ALERT SERVICE BULLETIN
Bell Helicopter **TEXTRON**

NO. 430-07-39

MODEL AFFECTED: 430

SUBJECT: TAIL ROTOR PITCH CHANGE MECHANISM,
REVISED RIGGING PROCEDURES

Figure 1. Tail Rotor Pitch Change Mechanism (Position)

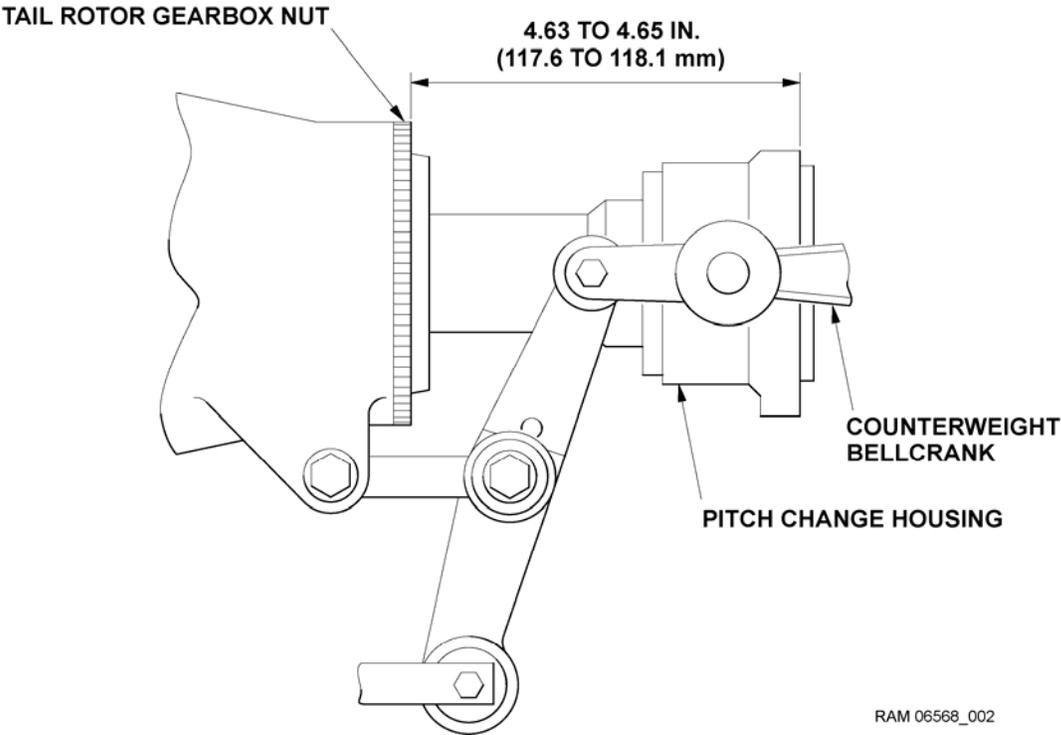
1. Move the tail rotor pedals as required and set the pitch change housing to obtain a 4.63 to 4.65 inches (117.6 to 118.1 mm) dimension as shown in Figure 1. Maintain this position.

Figure 2. Tail Rotor Pitch Change Mechanism

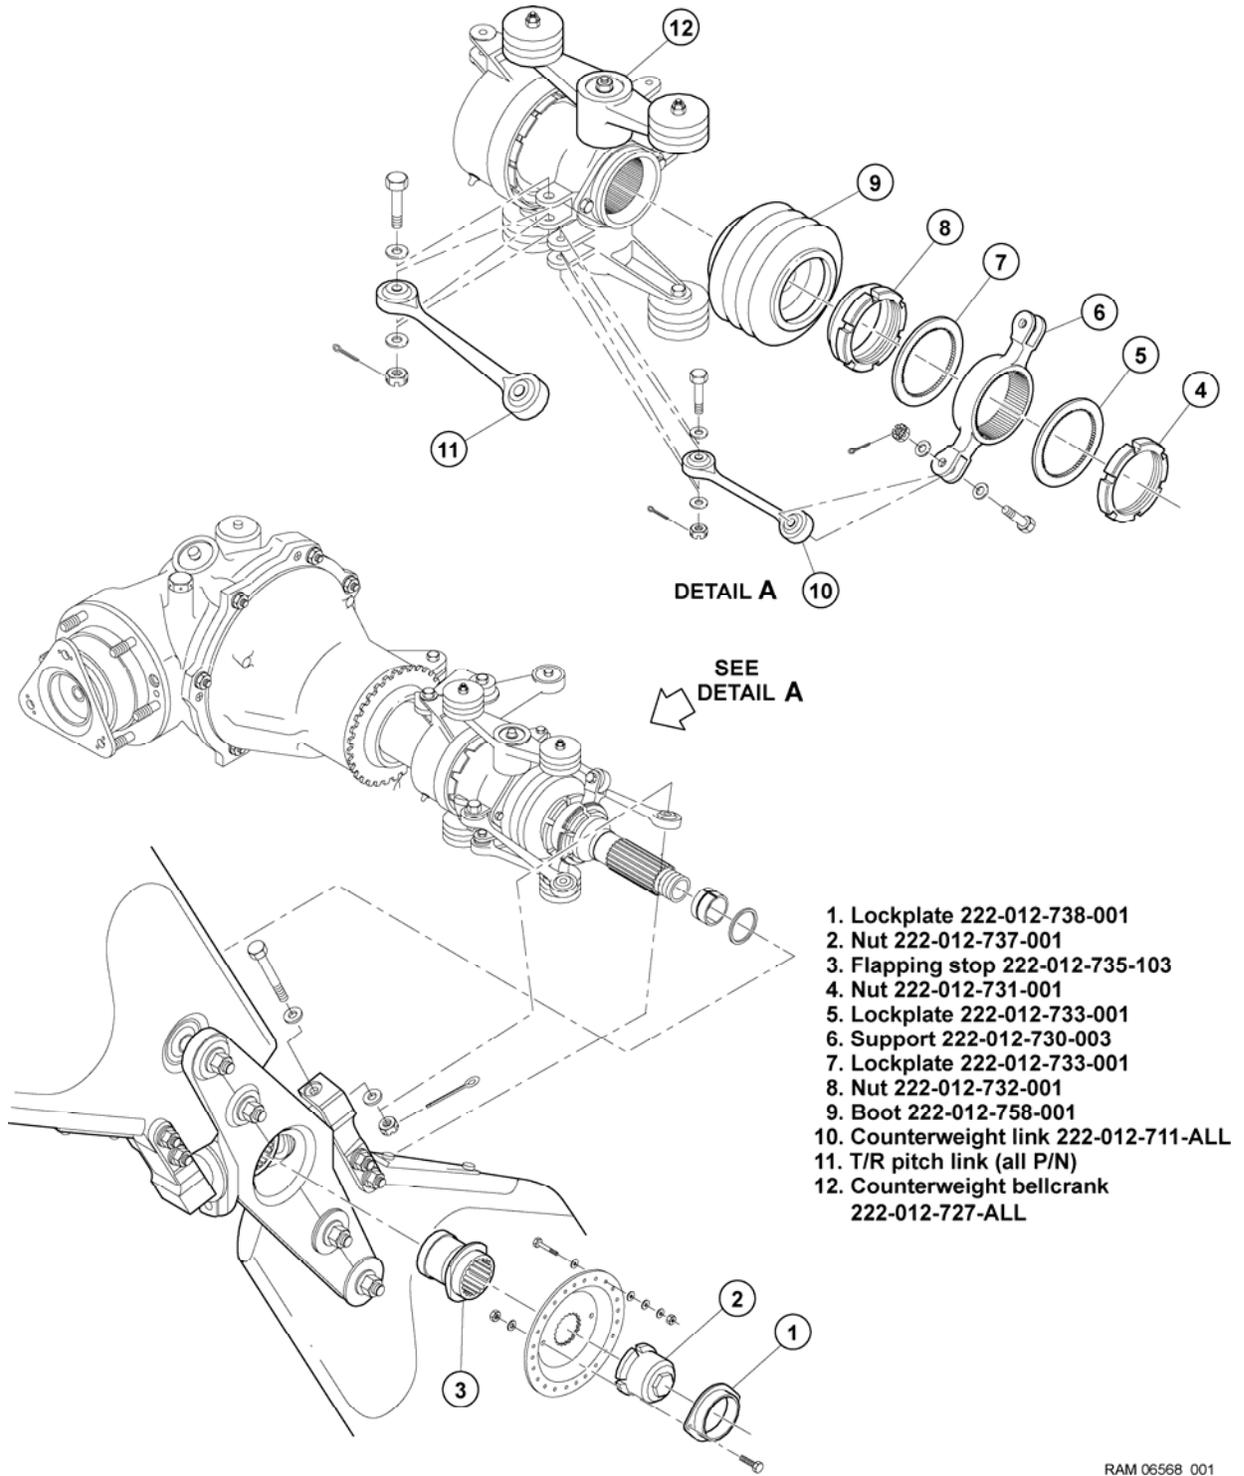
2. Verify that the centerline of counterweight bellcranks, (12, Figure 2) are parallel with the centerline of the tail rotor gearbox output shaft. If the counterweight bellcranks (12) are parallel with the centerline of the tail rotor gearbox output shaft, proceed to step 3. If the counterweight bellcranks (12) are not parallel with the centerline of the tail rotor gearbox output shaft, disconnect boot (9), pitch links (11) and counterweight links (10) as required. Straighten the bent edges of the lockplates (5 and 7) and adjust nut (4) and nut (8) to reposition support (6) until the counterweight bellcranks are parallel with the centerline of the tail rotor gearbox output shaft. Hold the nut (8) in position and torque the nut (4) to 50 to 55 foot-pounds (68 to 75 Nm). Do not bend the edge of the lockplates (5 and 7) into the slots of nut (4 and 8) at this time.

3. Move the tail rotor assembly through the full flap range (verify at both full flap positions). Verify if the tail rotor yoke touches the flapping stop (3) before it touches nut (4). If a gap exists between the tail rotor yoke and the flapping stop (3), replace the existing tail rotor yoke with yoke P/N 222-012-702-117. Notify BHT Product Support Engineering if yoke replacement is required.

4. If there is no gap between the flapping stop (3) and the tail rotor yoke, verify if a 0.020 inch (0.50 mm) wire type feeler gauge can be inserted between the tail rotor yoke and nut (4). If the smallest gap between the tail rotor yoke and nut (4) is 0.020 inch (0.50 mm) or more, bend the edge of the lockplates (5 and 7) into the slots of nut (4 and 8). Connect boot (9), pitch links (11) and counterweight links (10) as required and proceed to step 6.

Adjusting nut (4) and nut (8) to obtain a 0.020 to 0.030 inch (0.50 to 0.76 mm) gap between the tail rotor yoke and nut (4) will result in a minor misalignment of the counterweight bellcranks (12) in relation to the tail rotor gearbox output shaft. A maximum misalignment of 1.6 degrees of the counterweight bellcranks (12) in relation to the tail rotor gearbox output shaft is acceptable when the pitch change housing is positioned as shown in figure 1.

5. If the gap between the tail rotor yoke and nut (4) measures between 0.000 and 0.019 inch (0 to 0.48 mm), adjust nut (4) and nut (8) until a gap of 0.020 to 0.030 inch (0.50 to 0.76 mm) maximum exists between the tail rotor yoke and nut (4). Hold the nut (8) in position and torque the nut (4) to 50 to 55 foot-pounds (68 to 75 Nm). Bend the edge of the lockplates (5 and 7) into the slots of the nut (4) and nut (8). Connect boot (9), pitch links (11) and counterweight links (10) as required.
6. Examine and adjust the tail rotor pedal forces if any adjustments were carried out to support (6). Refer to BHT-430-MM-7, chapter 64-00-00.
7. Annotate helicopter records to reflect compliance with this bulletin.
8. Insert the BHT-430-MM-7 Revision 14, dated 15 Dec. 2006 into the BHT-430-MM-7 manual.
